ADDENDUM NUMBER 1

**Professional Development Center
and Kitchen**

For
SAN BERNARDINO CITY UNIFIED SCHOOL DISTRICT
Bid No F16-05

December 28, 2015

SECOND FLOOR
DEMOLITION PLAN

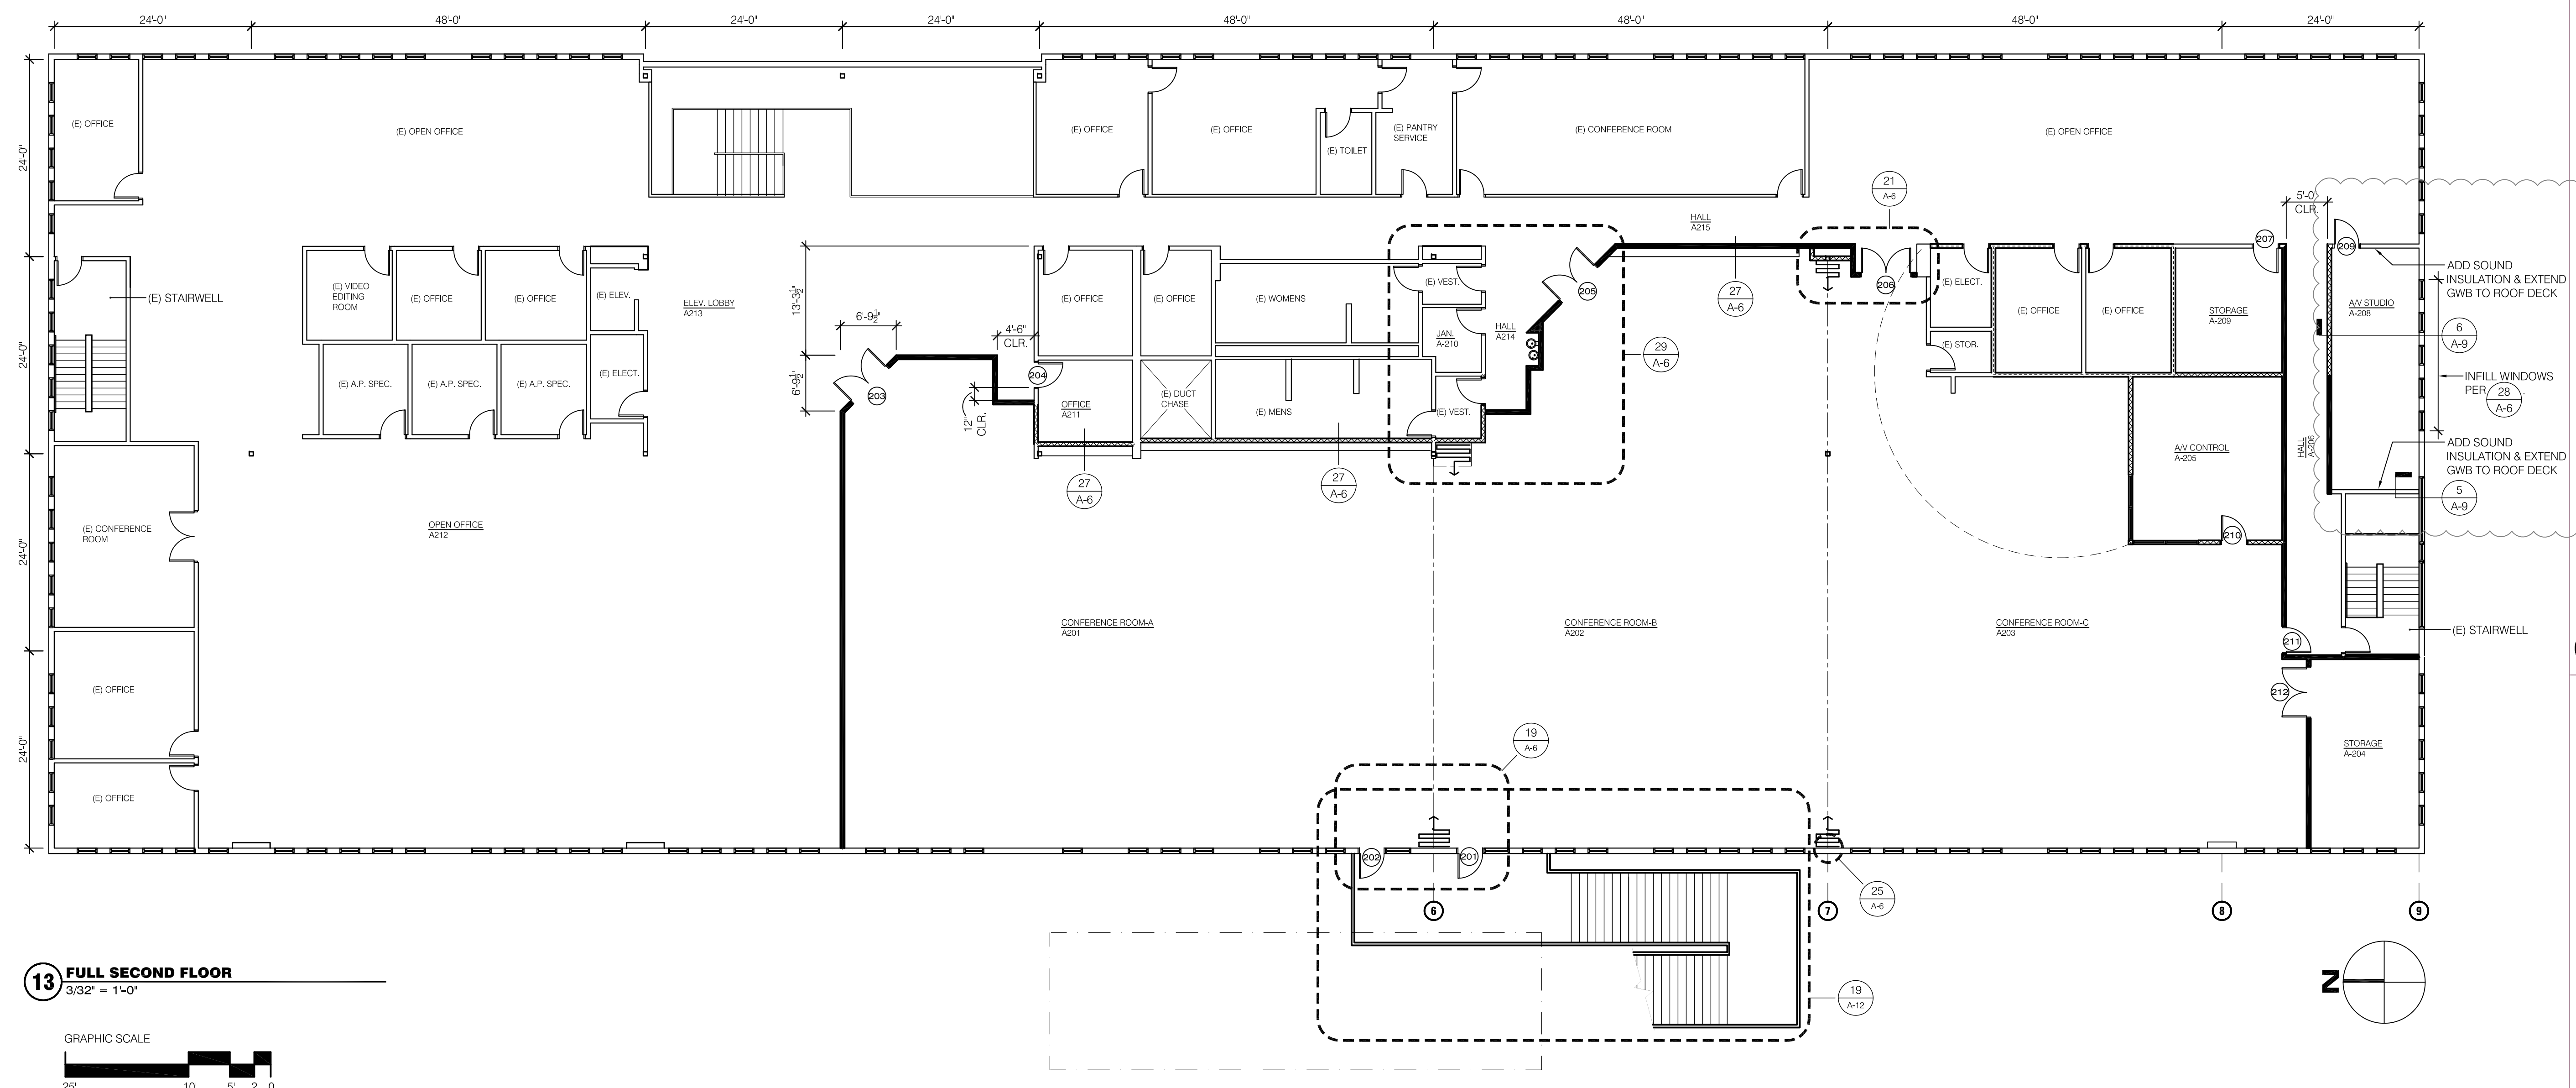
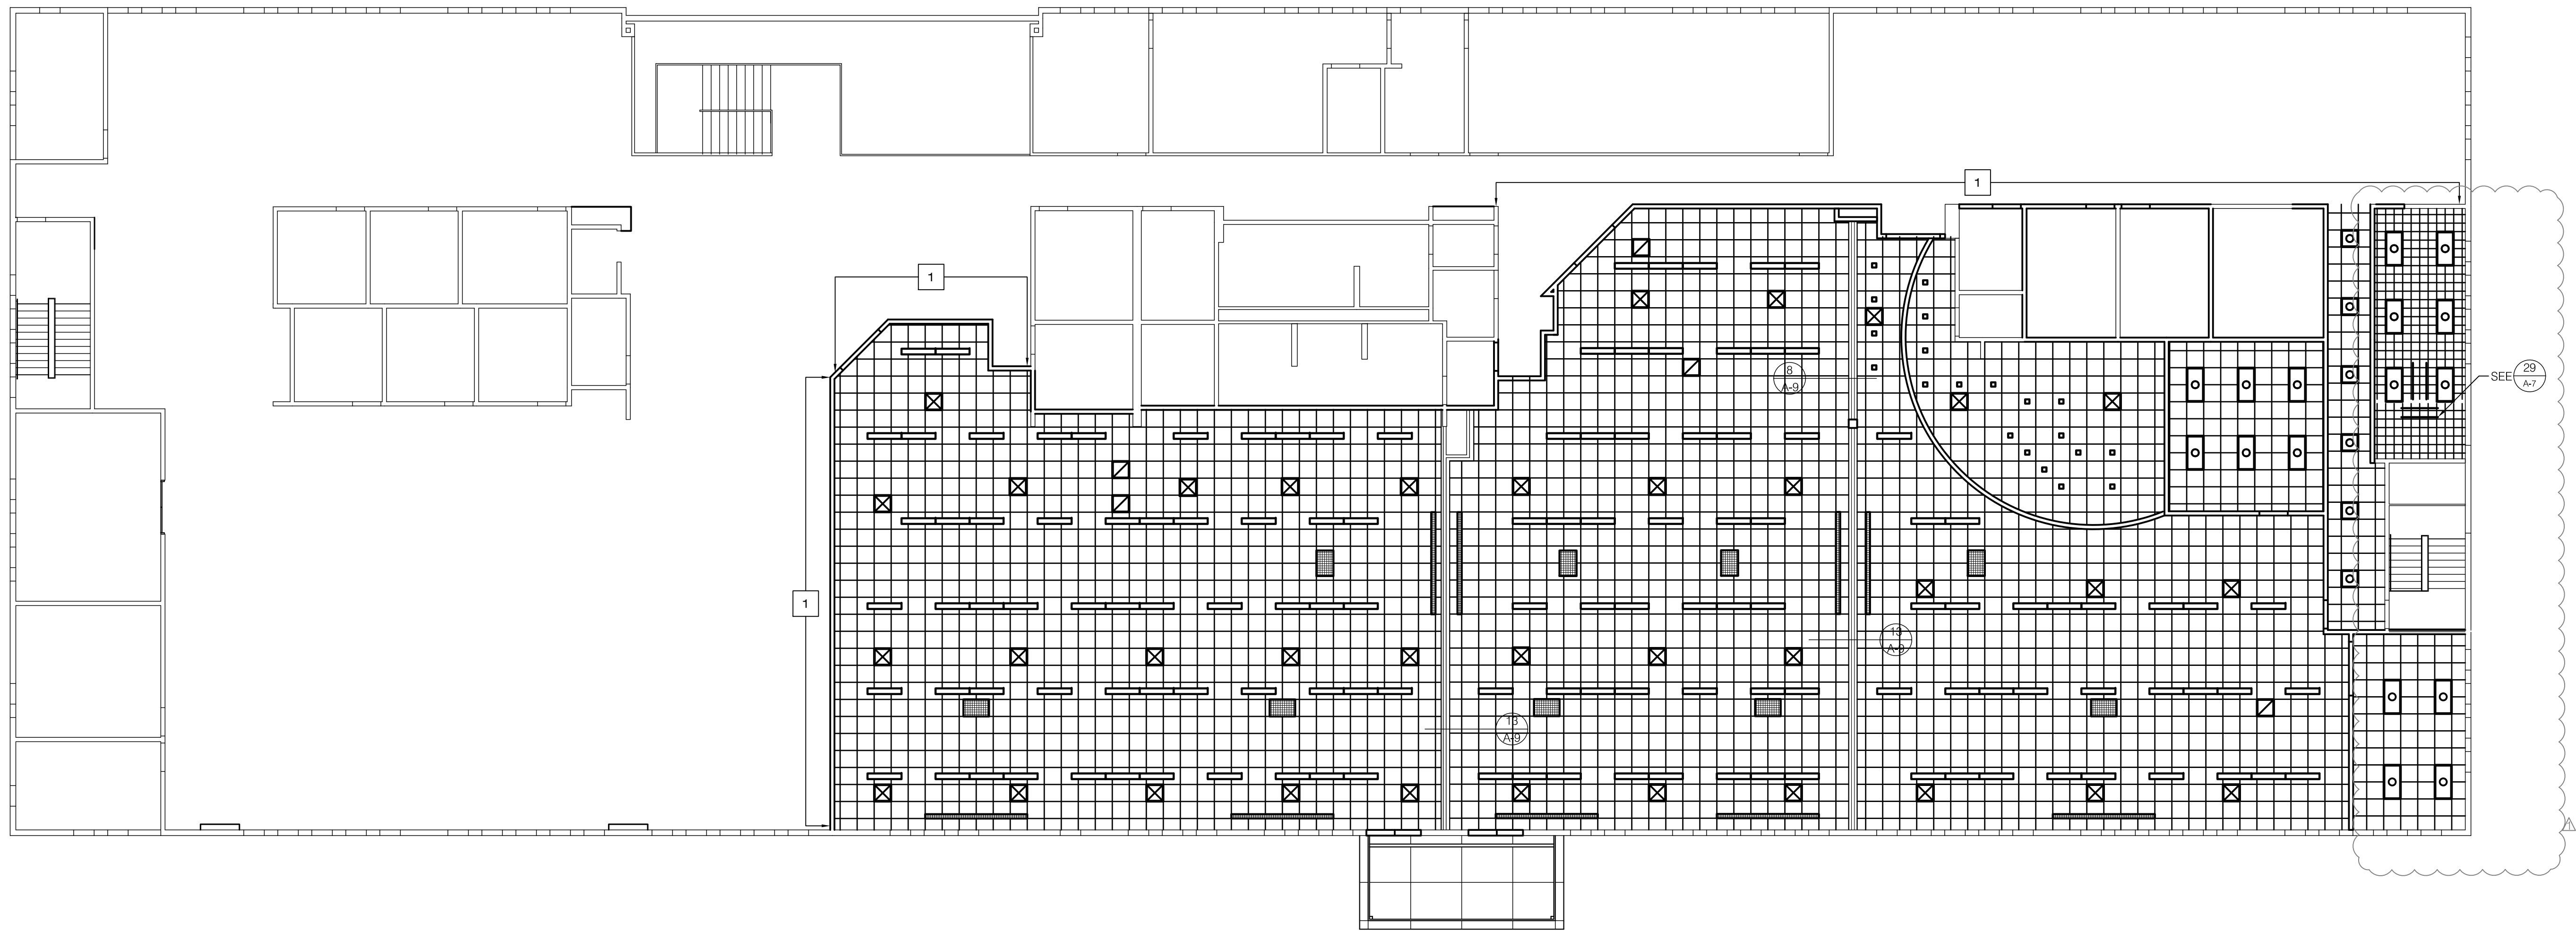
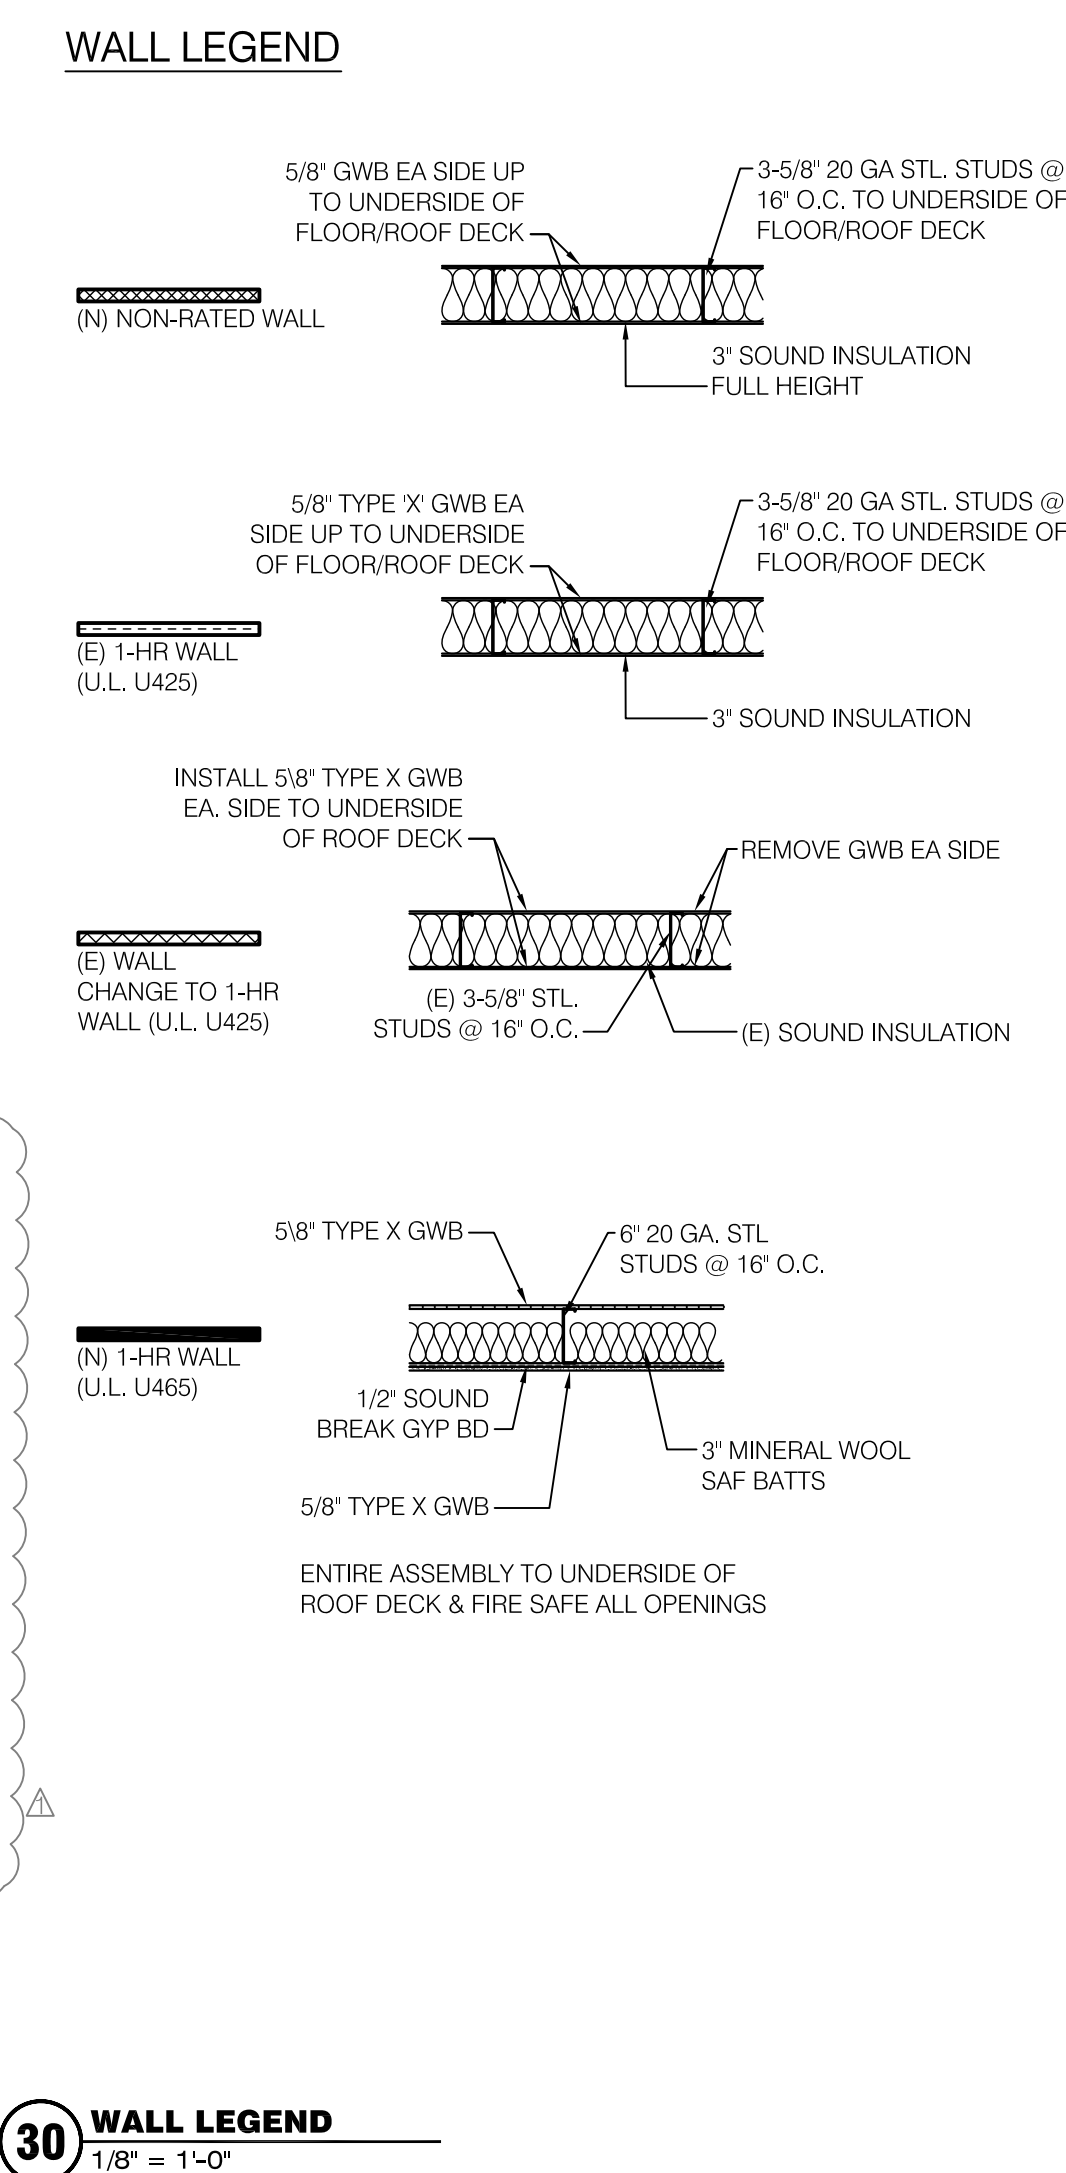
Item Number 22; Reference: Sheet A-5, Second Floor Demolition Plan; Replace this sheet with attached sheet **A-5, Second Floor Demolition Plan.**

Note: Revised sheet provides clarification of demolition work and relocation of existing dual drinking fountain
